DA2018/0852

PROPOSED GROUND FLOOR PLAN

PROJECT
ALTERATIONS AND ADDITIONS
LOT 24 SEC C DP 2610

DRAWING
PROPOSED GROUND
FLOOR PLAN

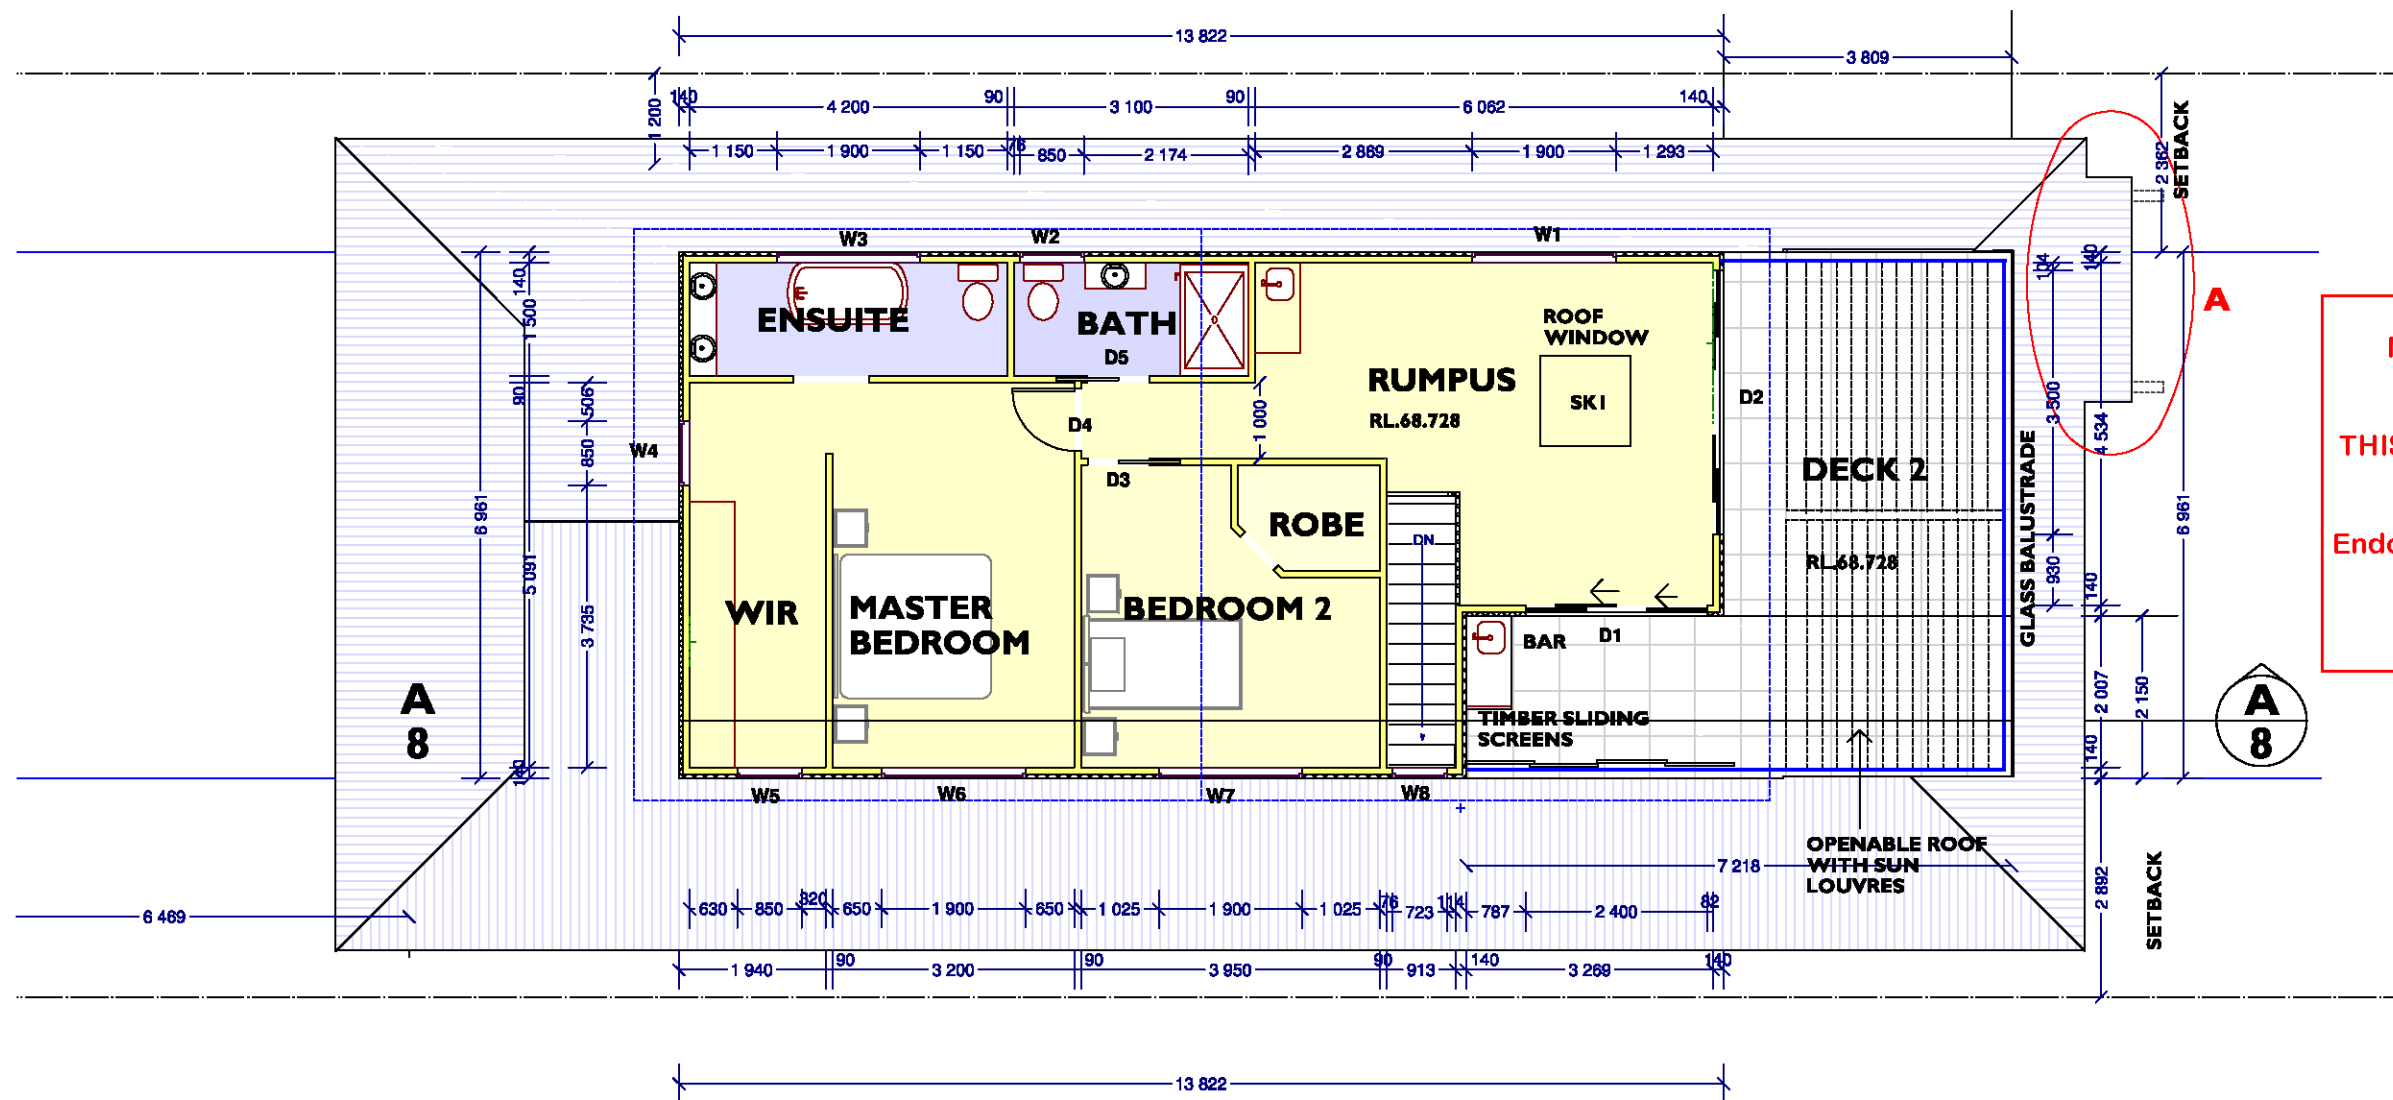
AMENDMENT A 5th Sep 2018
Front entry stair revised and set back a further
1m from boundary to allow for neighbours views
Basix amended for W10 & W18

DRAWING
PROPOSED FIRST
FLOOR PLAN

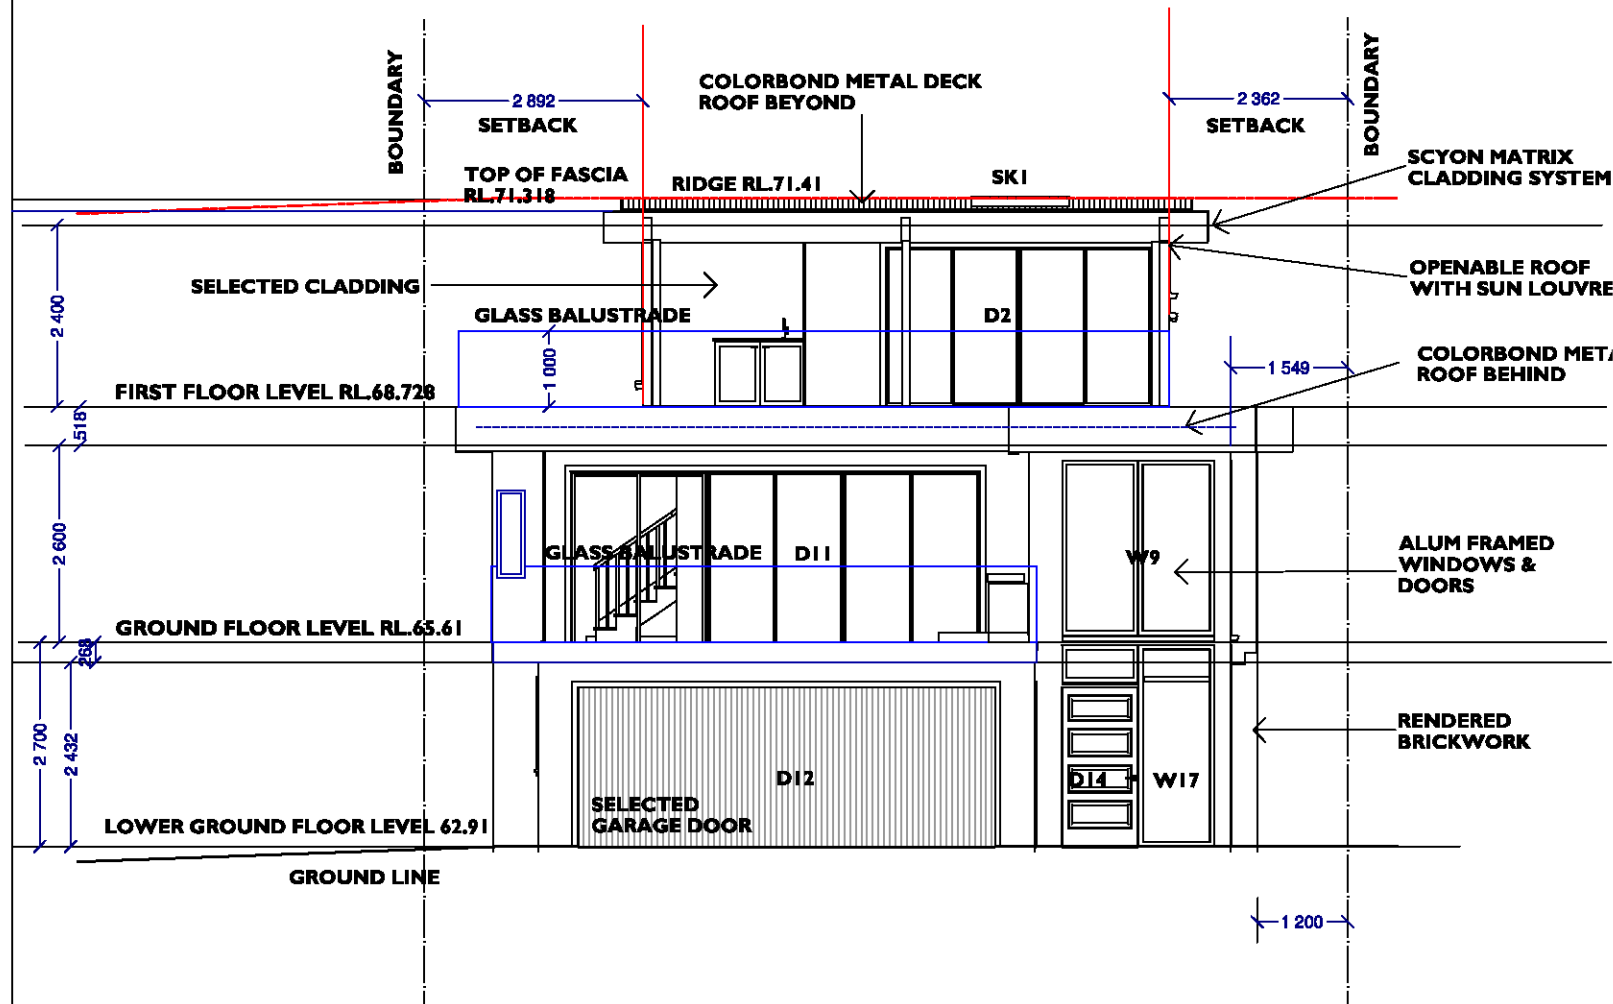
AMENDMENT A 5th Sep 2018
Front entry stair revised and set back a further
1m from boundary to allow for neighbours views
Basix amended for W10 & W18

DRAWING
SOUTH & NORTH ELEVATIONS
WINDOW & DOOR SCHEDULE

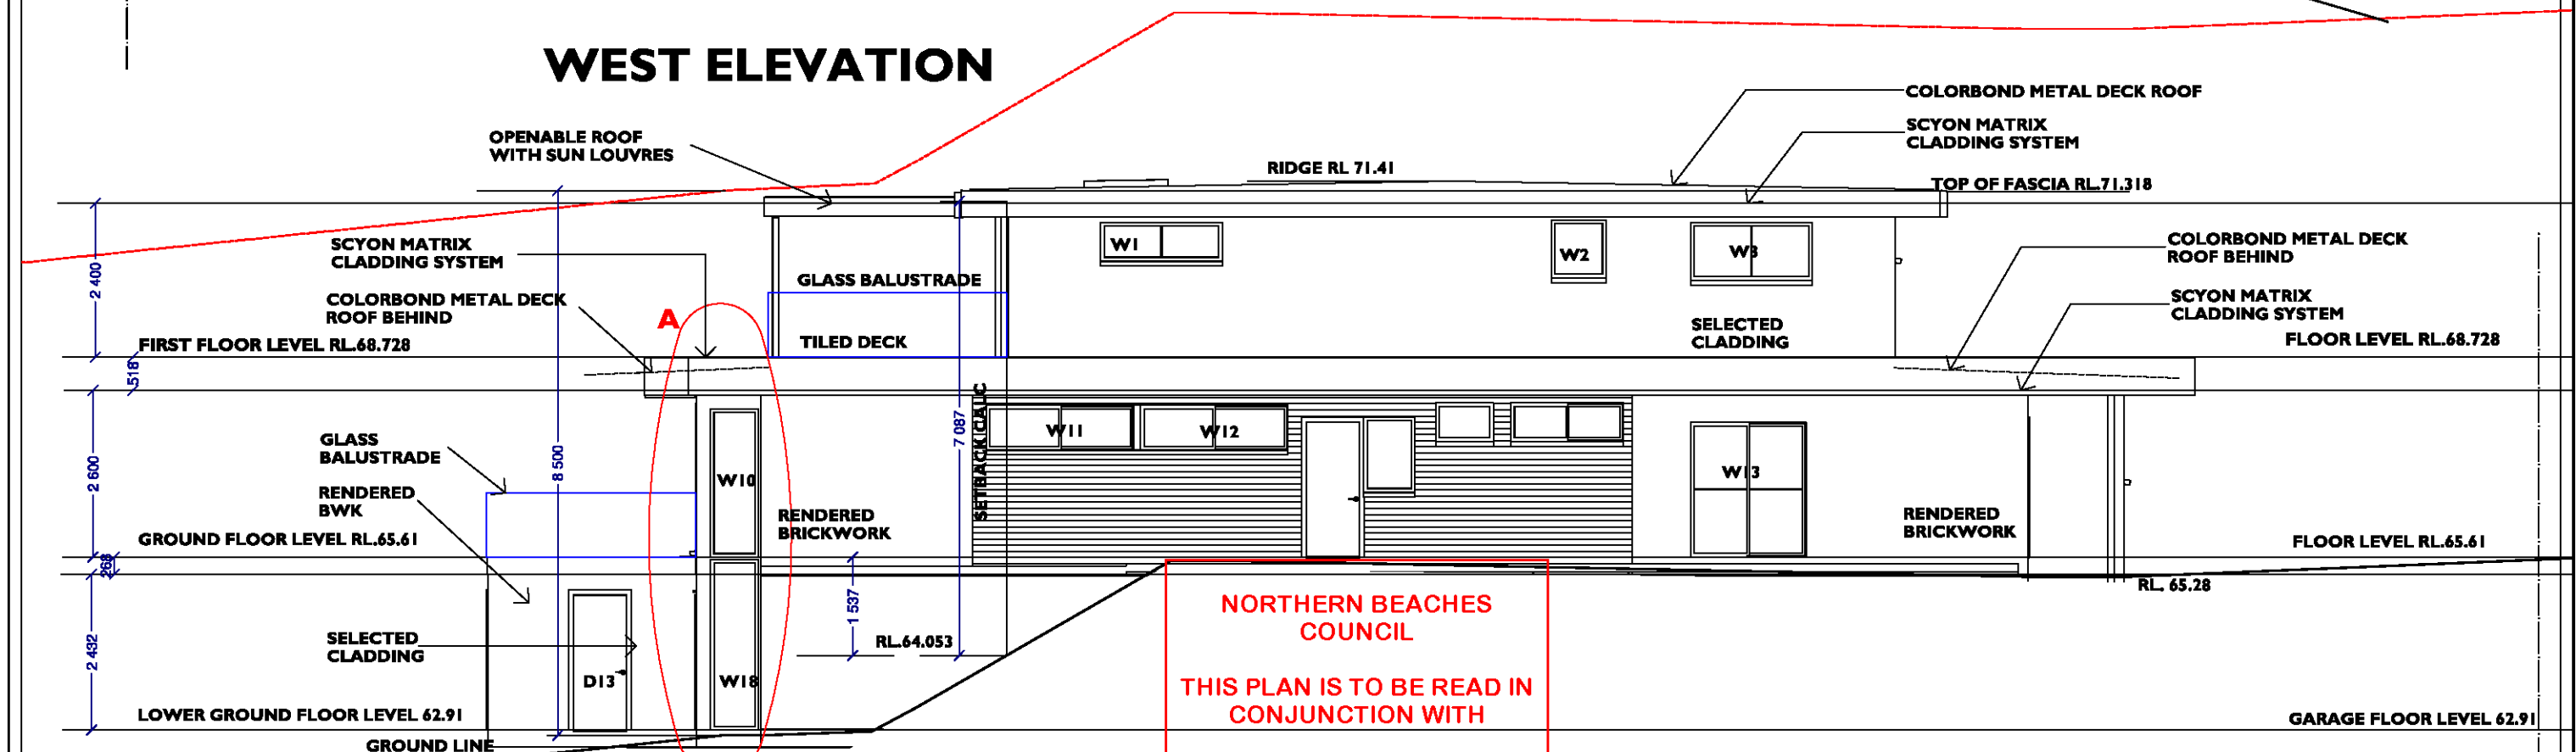
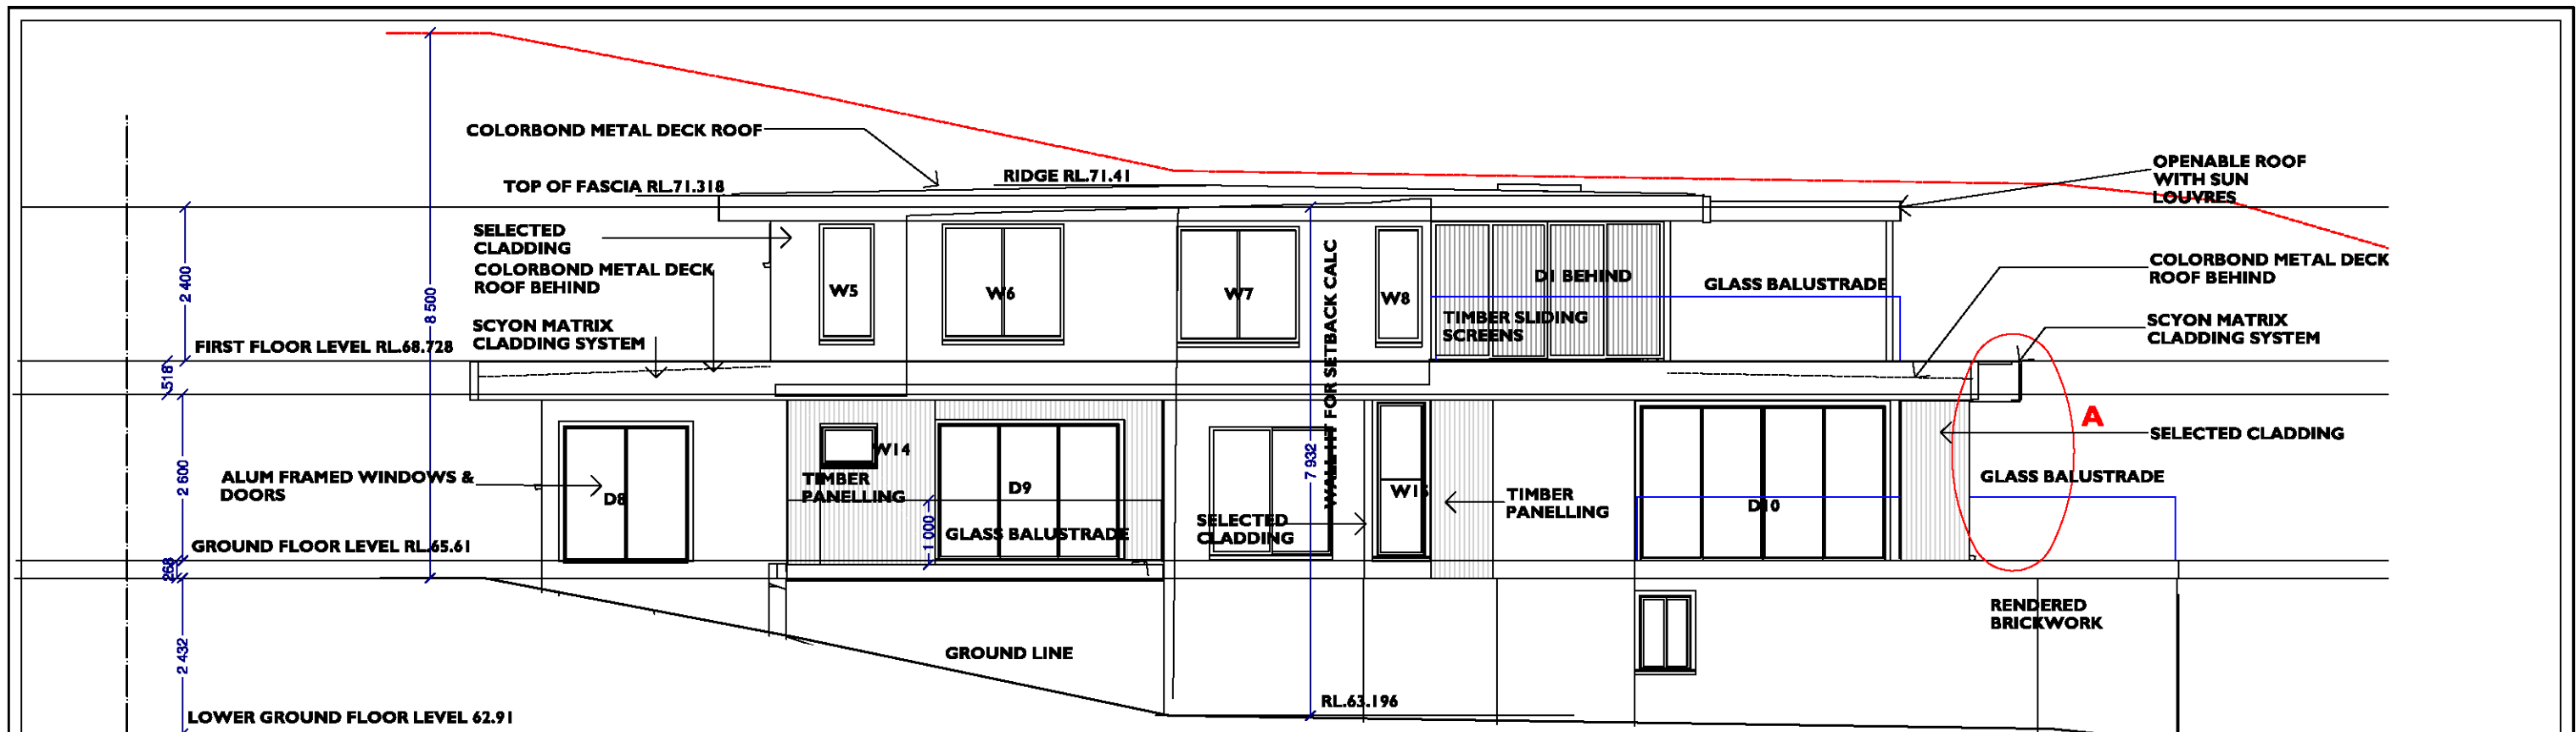
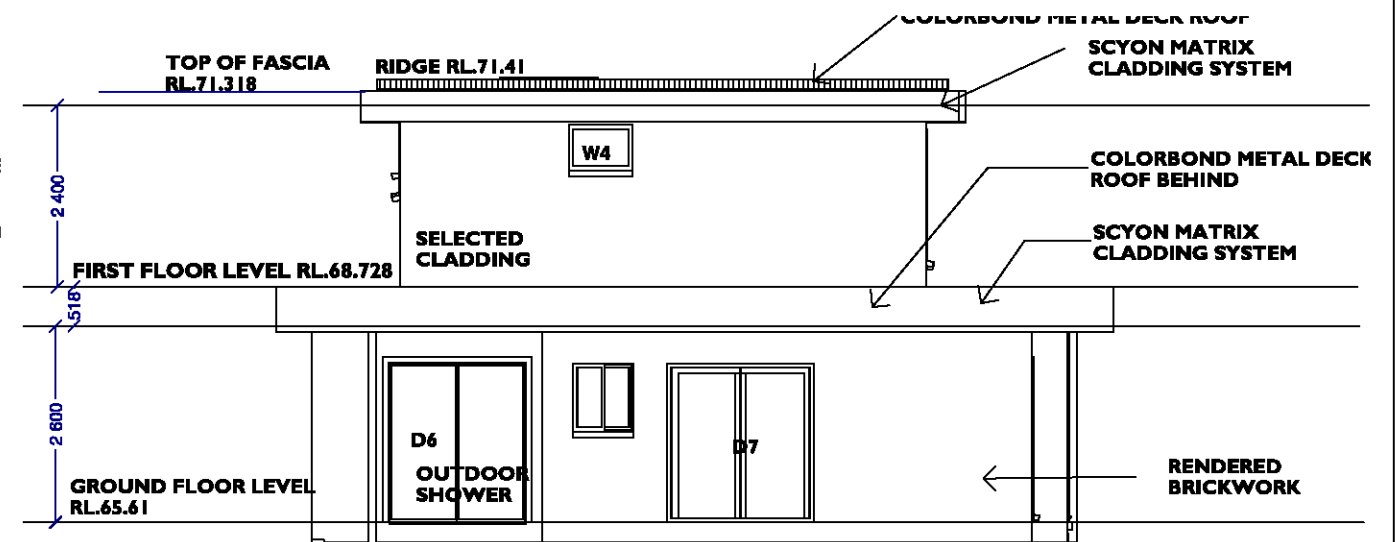
AMENDMENT A 5th Sep 2018
Front entry stair revised and set back a further
1m from boundary to allow for neighbours views
Basix amended for W10 & W18

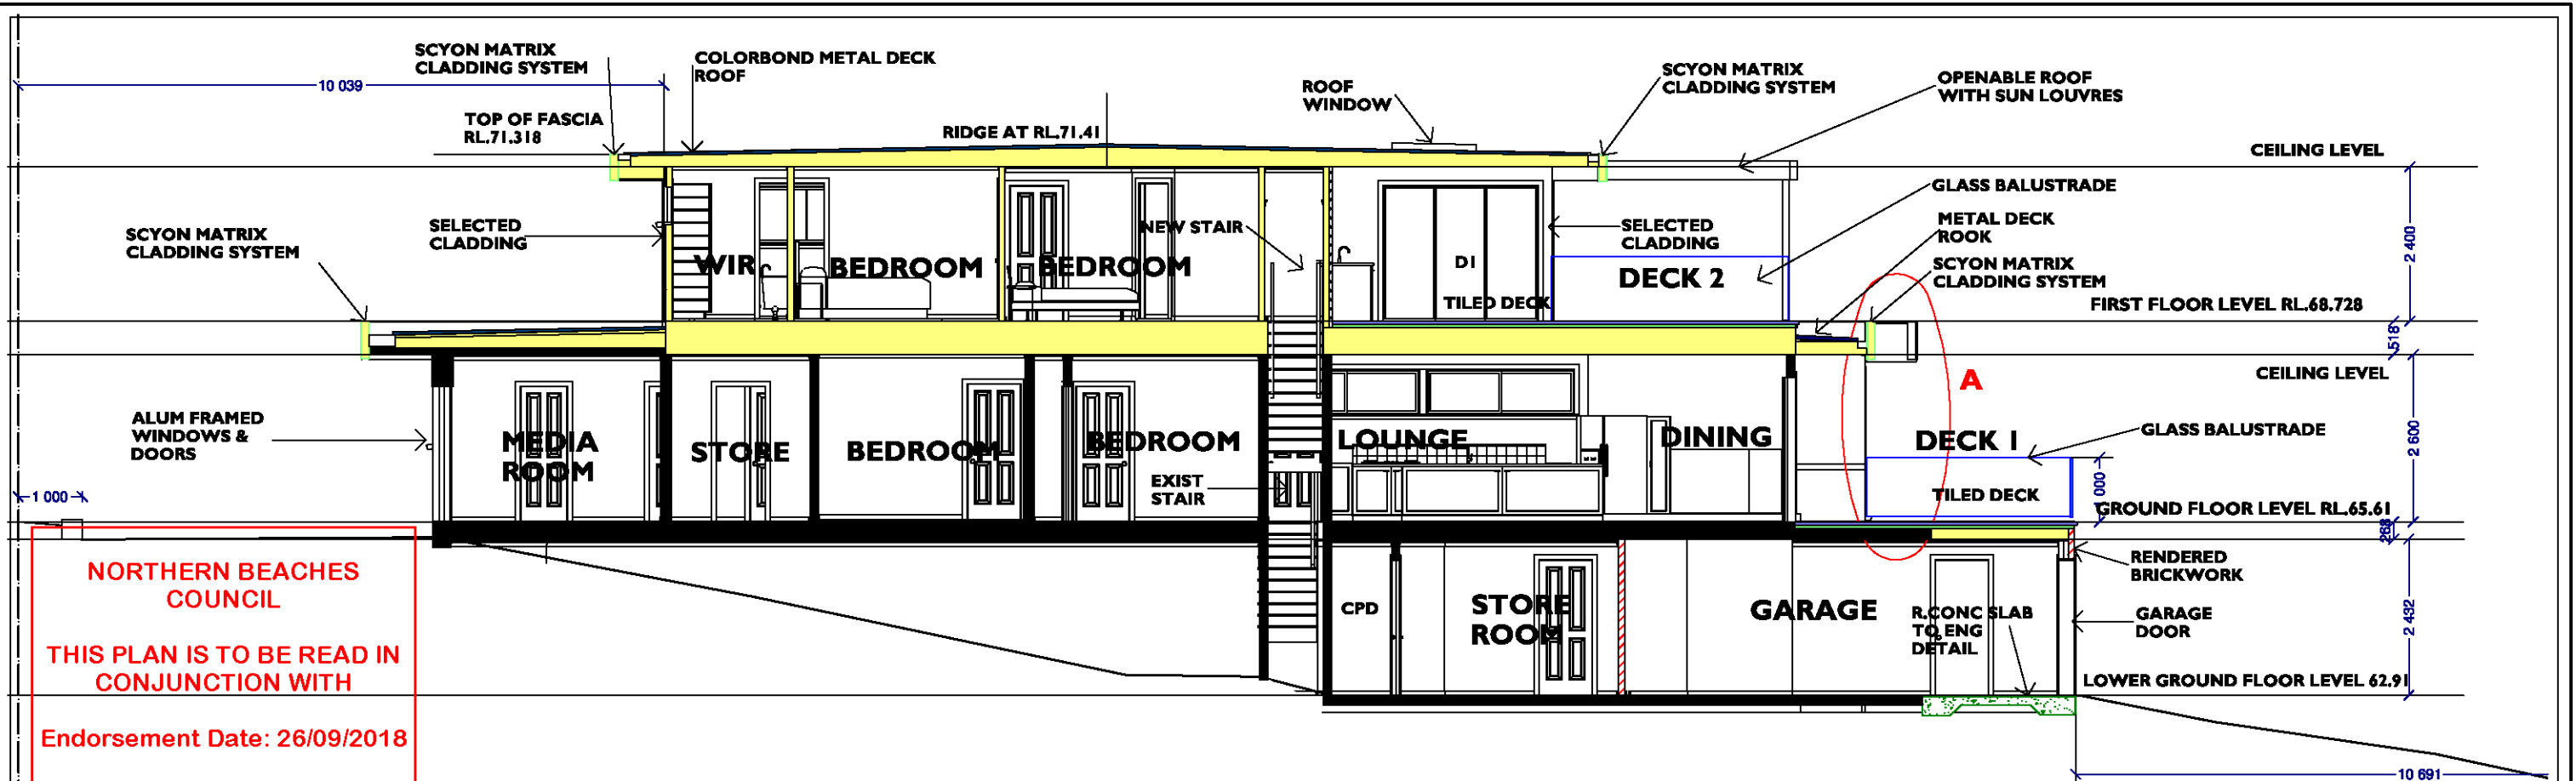
DRAWN BY Raise the Roof DESIGN BY : Mike Wilcox ENQUIRIES E. raisetherooft1@optusnet.com.au	CLIENT Mrs Heidi Dunbar Jonson 12 Moore Street Clontarf	PROJECT ALTERATIONS AND ADDITIONS LOT 24 SEC C DP 2610	DRAWING WEST AND EAST ELEVATIONS	AMENDMENT A 5th Sep 2018 Front entry stair revised and set back a further 1m from boundary to allow for neighbours views Basis amended for W10 & W18 Any design work created by Raise the Roof is the property of Raise the roof and may not be reproduced in any way without written permission DATE 12th Mar 2018 REVISION 5th Sep 2018 SCALE 1 : 100	DWG. 7 A
---	--	--	-------------------------------------	--	-----------------------
